Comment Set E3
Southern California Edison Company

Devers–Palo Verde No. 2 Transmission Line Project

From: Thomas.Burhenn@SCE.com [mailto:Thomas.Burhenn@SCE.com]
Sent: Thursday, August 10, 2006 4:39 PM
Subject: comments on Noise issues

SOUTHERN CALIFORNIA EDISON COMPANY’S (U 338-E)
 DPV2 - PHASE II LATE-FILED EXHIBIT

Figure 1
Magnetic Field Level Changes By Increasing Proposed Tower Height By 10 Feet Increment

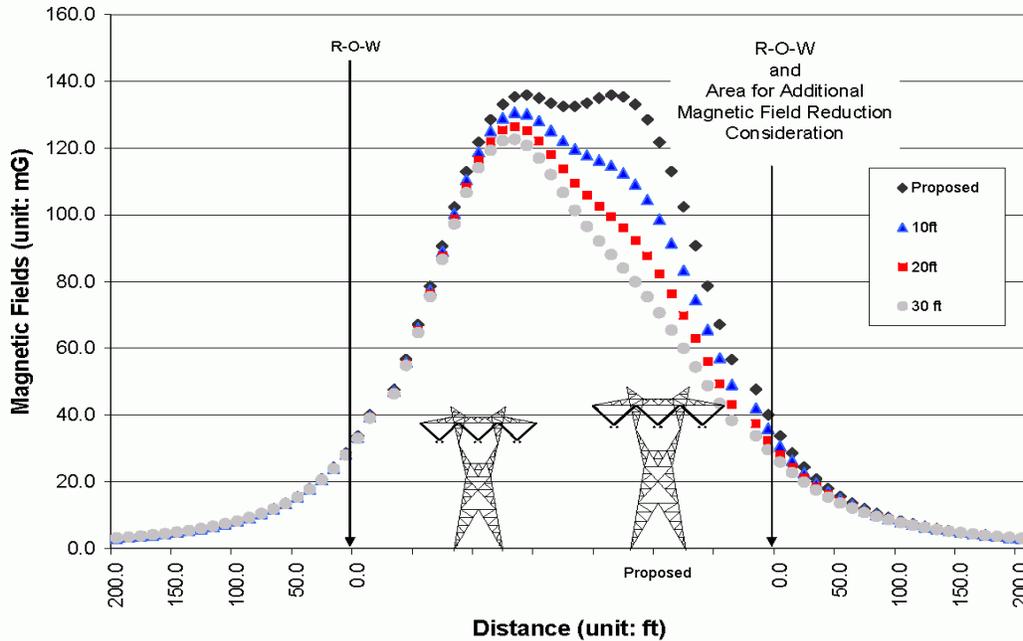
Using taller towers reduces the magnetic field at the edge of the ROW². Figure 1 and Table 1 below illustrates the magnetic field level changes expected by increasing tower heights for the proposed 500 kV transmission lines. Figure 1 and Figure 2 show that the magnetic field level changes beyond 50 feet from

the edge of the ROW for using taller towers are insignificant. In summary, there will be no decrease in magnetic field levels for those residences which are located more than 50 feet from the edge of the ROW.

In order to reduce magnetic field levels by 15% or more at the edge of ROW, SCE would need to raise about thirty-three towers (including six dead-end towers) by 20 feet or more. The estimated incremental cost to perform this work is approximately \$1,400,000. SCE basis this estimate upon a set of assumptions that includes the cost of additional labor, materials, P&B, A&G, AFUDC, and a 15 percent contingency needed for raising a typical 150 feet tower to a 170 feet tower. However, since tower designs have height limitations, if any proposed tower height is already taller than about 170 feet, the additional 20 foot height increase may require a different tower design, and the estimated cost will be significantly greater, mainly due to the additional structural strength needed for heavier and taller towers.

*Figure 2
SCE's Proposed Design*

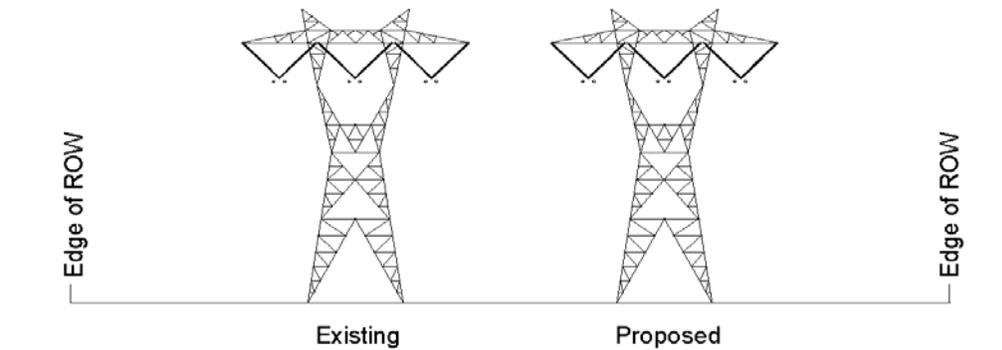
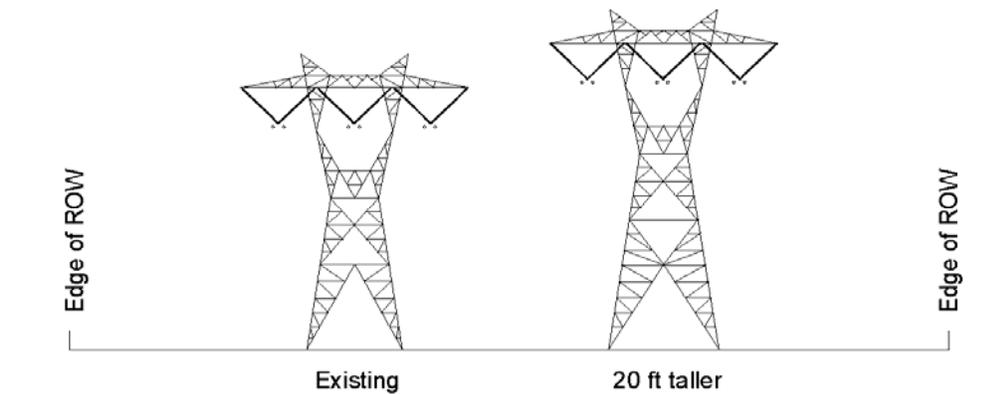
Figure 2 below provides an illustration of SCE’s proposed design for the Devers-Harquahala and Devers–Valley 500 kV transmission line corridors. The “proposed” tower type and height will match the adjacent “existing” Devers-Palo Verde or Devers-Valley (DV) 500 kV transmission lines, to the extent feasible. Table 1 above illustrates the visual characteristics of using a taller tower for the “proposed” 500 kV transmission lines.

Figure 3 is the model for evaluating magnetic field reductions by using taller towers, as the ALJ directed. The “existing” tower height will remain unchanged.

Constructing new towers that would exceed the heights of the existing 500kV towers, located within parallel and adjacent rights-of-way by 20 feet or more, will increase visual impacts. The

differential height of the towers and conductors would result in higher levels of visual contrast to viewers from residential areas and travel ways within the affected areas. The construction of these taller structures also conflicts with the recommended mitigation measures in the Draft EIR/EIS (CPUC and Bureau of Land Management, v.1, Part 1, May 2006), on page D. 3-64 of the EIR/EIS, which states:

Therefore, implementation of the EMF Policy would not change the Visual Resources impact classifications along the Devers-Valley Alternative nor would it affect Mitigation Measures V-3a and V-40a, both of which include the phrase “to the extent possible.” Additionally, tower design and span distances should not be substantially affected by increased tower heights at the selected locations.

ACDC AUDIBLE NOISE CALCS
DEVERS - PALO VERDE 2
CASE 2
6/9/05

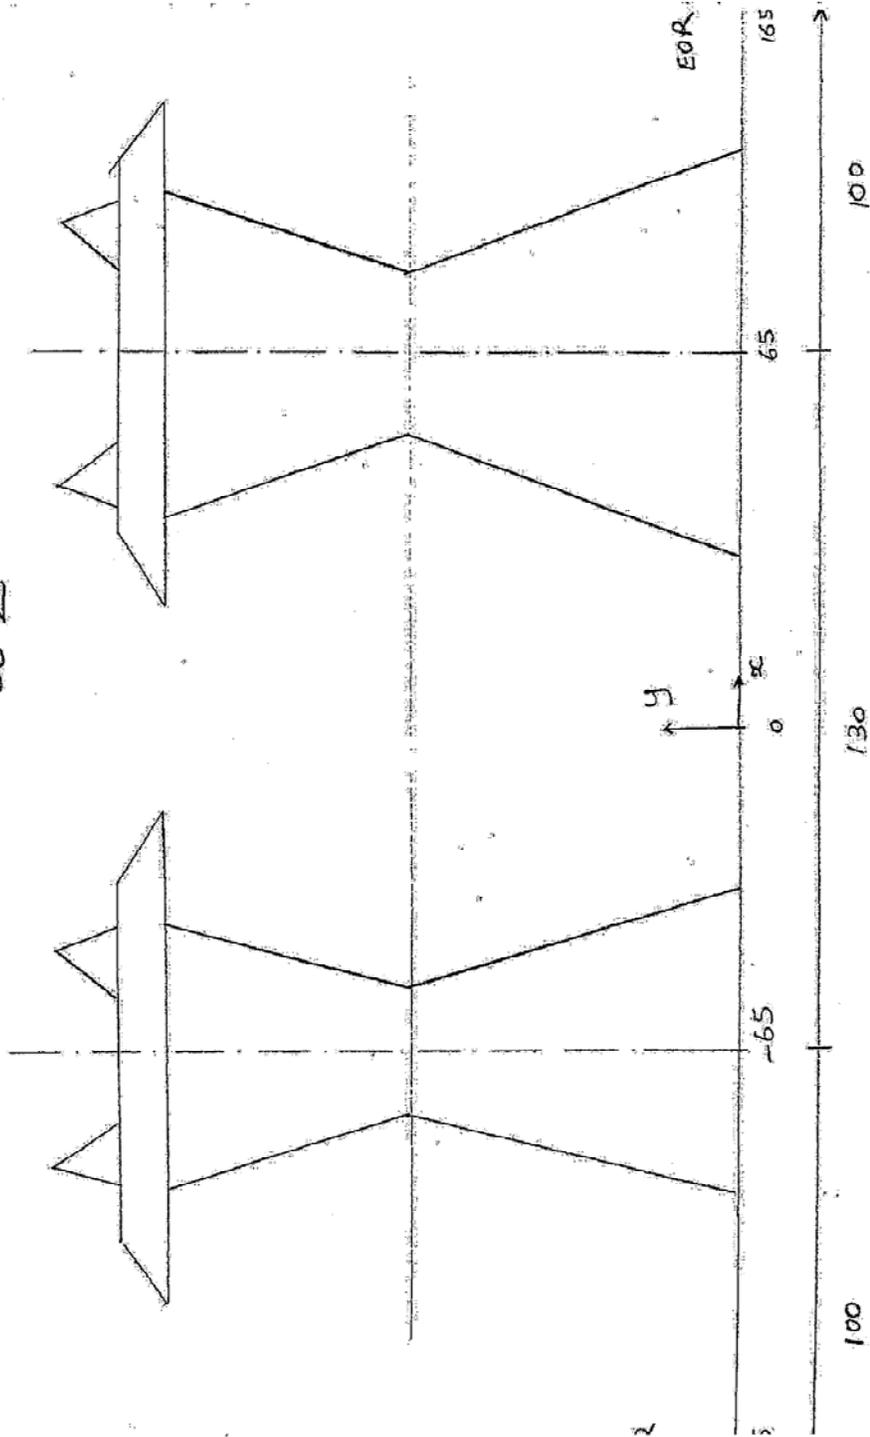
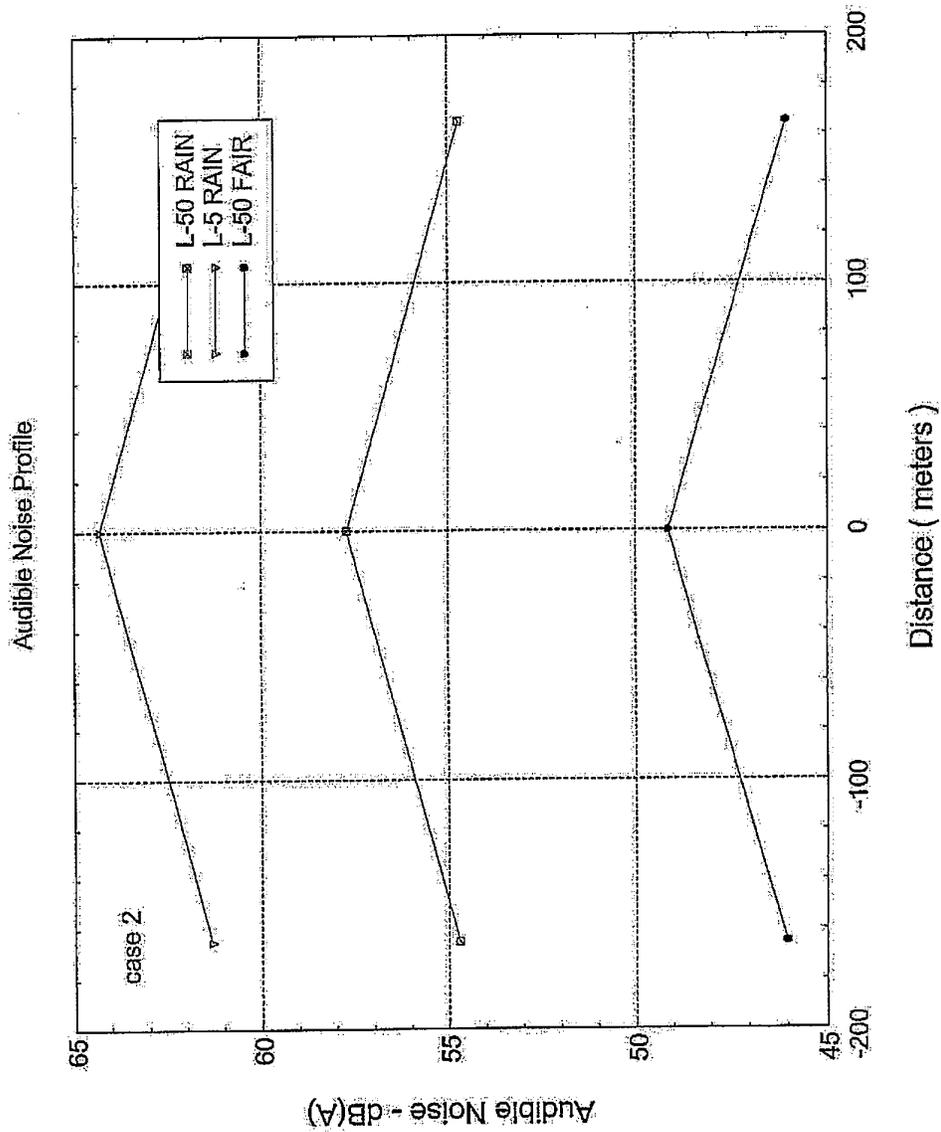
Another weighted average noise measure is the Community Noise Equivalent Level (“CNEL”). CNEL is the average equivalent A-weighted sound level during a 24-hour day, obtained after addition of 5 decibels to sound levels in the evening from 7:00 p.m. to 10:00 p.m. and after the addition of 10 decibels to sound levels in the night from 10:00 p.m. to 7:00 a.m. The State Department of Aeronautics and the California Commission on Housing and Community Development have adopted the CNEL. Both the City and County of Riverside use the CNEL descriptor. The Riverside County maximum allowable CNEL value is 65 dBa. A value of 61.3 dBa (L5) has been used by SCE in its CPUC filing. The corresponding CNEL value is 67.7 dBa, which exceeds the County requirement.

A review of other projects filed throughout California with the California Energy Commission has identified that the L50 descriptor is used in Riverside County. For this project, the L50 noise value is 54.7 dBa. The corresponding CNEL value is 61.4 dBa, which is under the 65 dBa requirement.

E3-1 The Draft EIR/EIS for DPV2 shows that Riverside County considers noise sources in excess of 65 CNEL to be incompatible with residential uses [Policy N.1.3, DEIR/EIS p. D.8-13]. CNEL is a term defined by the California Governor’s Office of Planning and Research and others as an industry-standard metric. Sources of noise that occur both day and night are “penalized” during evening and nighttime hours to account for the nighttime sensitivity of people [DEIR/EIS p. D.8-1].

Information provided by SCE in the August 1, 2006 late-filed exhibit gives more detail on the time-varying nature of corona noise levels after construction of the second 500 kV line. The information in the comment clarifies that 61.3 dBA is the “L5” level, the level that would be exceeded five percent of the time. This is new information because no metric was given earlier, and the 61 dBA value had been assumed to be the Leq in the Draft EIR/EIS. The Draft EIR/EIS incorrectly converted the L5 value to a CNEL metric to determine compliance with the local Riverside County policies. The August 1, 2006 late-filed exhibit includes an attachment (Attachment C, Sargent & Lundy Report on Corona Noise) showing the modeled L5 along with the Leq, the Ldn, and the L50, a level that would be exceeded 50 percent of the time. The comment then incorrectly converts the L50 level to CNEL. The comment asserts that the L50 should be used to determine compliance with the CNEL requirements, but the Ldn should be used here since it is a more-relevant metric being computed on a 24-hour term.

Using the methods of the Electric Power Research Institute-High Voltage Transmission Research Center (EPRI-HVTRC), the Ldn noise levels were calculated in the attachment to the comment. Without the Proposed Project, the EPRI-HVTRC report shows the baseline levels to be 64.0 dBA Ldn. For the Proposed Project, which would cause a corona noise maximum of 61.3 dBA L5, the EPRI-HVTRC report shows 54.7 dBA as the L50 and 65.7 dBA as the Ldn. The EIR/EIS has been revised to show these Ldn levels as project impacts. Because Ldn and CNEL are practically interchangeable terms here, this comment does not change the conclusion of the Draft EIR/EIS (Impact N-2) that levels along either the proposed Devers-Harquahala segment or the Devers-Valley No. 2 Alternative could exceed 65 CNEL. This means that the Class I impact identified in the Draft EIR/EIS remains in the Final EIR/EIS, but the extent of this impact is substantially reduced because it is less dramatically in excess of 65 CNEL. As such, the area of impact is reduced by an order of magnitude from 200 feet of the edge of ROW to occur only at those locations within about 25 feet of the ROW. The backyards and outdoor spaces of adjacent residential properties would experience this impact and few, if any, residential structures (not more than four along Devers-Harquahala and 25 along Devers-Valley No. 2).
